MIL-D-2940A
INTERIM AMENDMENT-3(SHIPS)
5 April 1973

INTERIM AMENDMENT

MILITARY SPECIFICATION

DAMPENERS, FLUID PRESSURE, GAGE PROTECTION

Figure 1 - External threaded end connection.

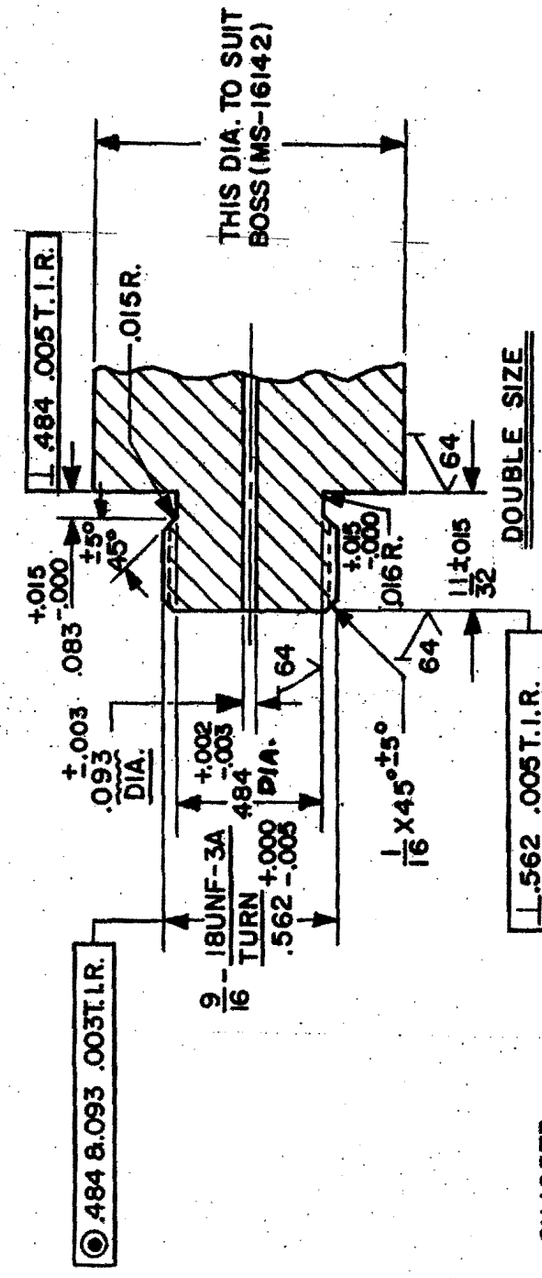
Thread size	Applicable document
9/16-18UNF-3B internal Threaded for "O" ring	MS16142
9/16-18UNF-3A external Threaded for "O" ring	Figure 1 herein"

Add the attached figure 1.
